REQUEST FOR INFORMATION	DATE: May 03, 2016	NO.: RFI-057
--------------------------------	---------------------------	---------------------

Project Name: Webster University Interdisciplinary Science Building Project No.: 15051

Subject: Additonal custom fin detail

REQUEST FOR INFORMATION DATE: April 20, 2016 NO.: RFI-044

12 PLAN DETAIL - CURTAINWALL SNAP COVER

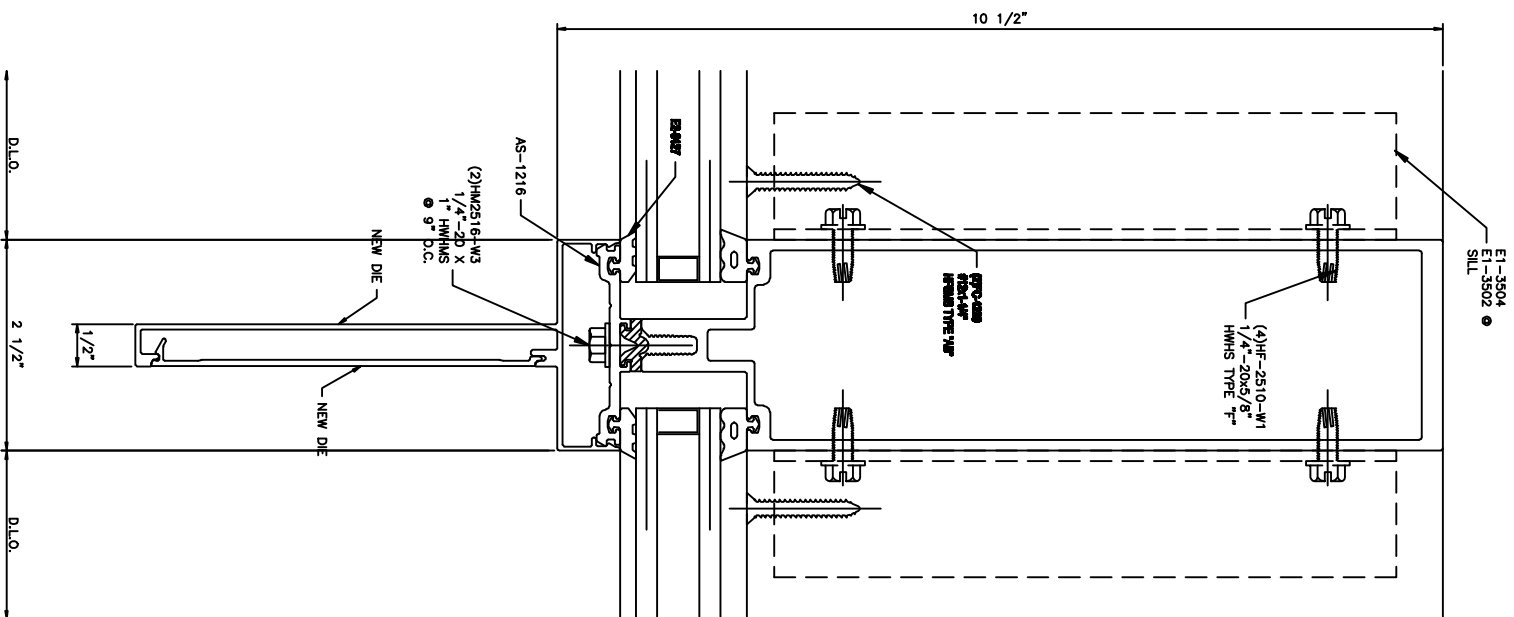
CURTAINWALL MANUFACTURE TO PROVIDE CLOSURES (TOP & BOTTEM FOR CUSTOM ALUM SNAP COVERS) ILLUSTRATE IN SHOP DRAWINGS BOTH CUSTOM ALUM CLOSURES AND MOVEMENT SPLICE JOINTS

1. MILLION WITH PROJECTED COVER

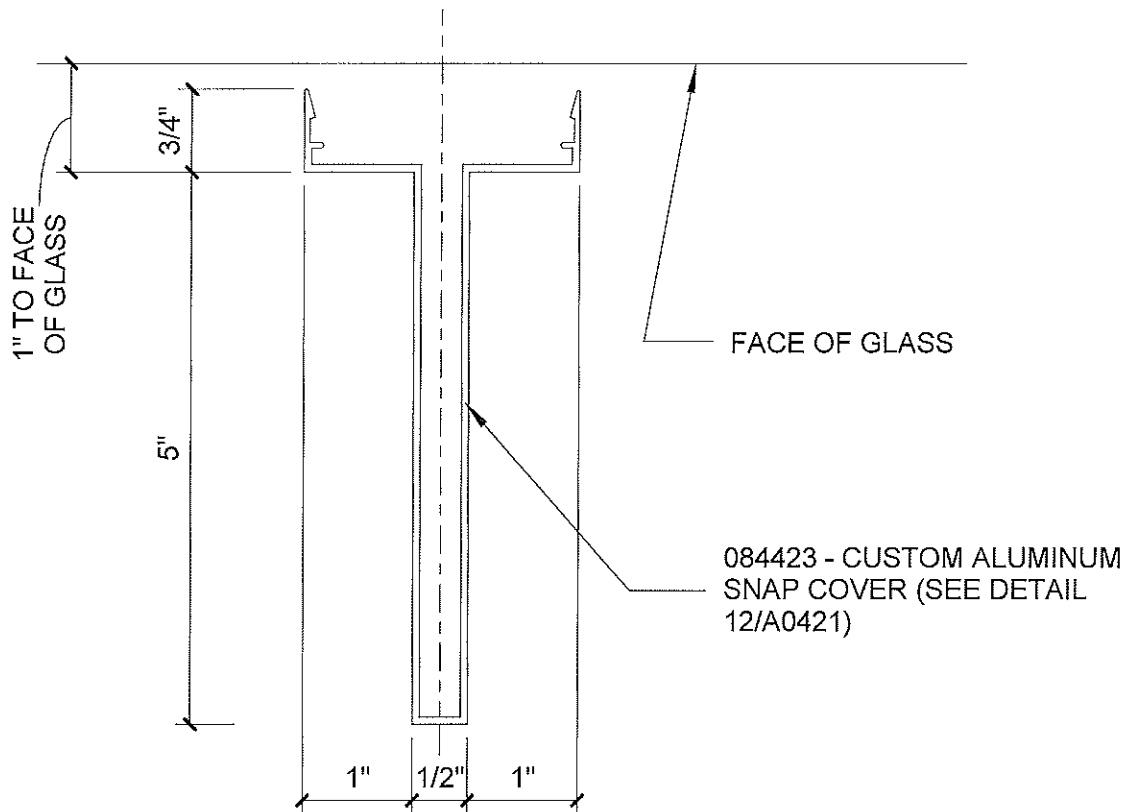
See attached detail 12/A0421 of the architectural drawings illustrating the custom fin design. In order to extrude this we had to modify the design slightly in order for it to work (see attached). The drawings call for closures at top and bottom of the fins as well as movement splices.

NGG requests we cap off the tops and bottoms and eliminate any splices. Please confirm.

If we cap off only at the top/bottom of the wall and use splices in between we allow an opportunity for water to get in to the cavity, build up and eventually freeze. This freezing would more than likely cause the snap in shape of our design to pop off the building. If we cap off each end of each piece we eliminate that possibility.

NGG's proposed snap cover does not satisfy the design intent.

The design intent is to have a seamless continuous appearance for the fin.

Below are some observations-

- 1) The proposed snap cover (fin) creates a break at the horizontal movement joint which does not satisfy the design intent.
- 2) We are concerned that the additional snap piece in the proposed snap cover extrusion might interfere with the movement of splice at the horizontal movement joint and changes the appearance.
- 3) Potential solution: Snap cover can be capped at the top, spliced at the horizontal movement joint, capped at the bottom of the lower piece with some holes to allow for moisture drainage.
- 4) Submit a sample of fin based on proposed design for consideration.
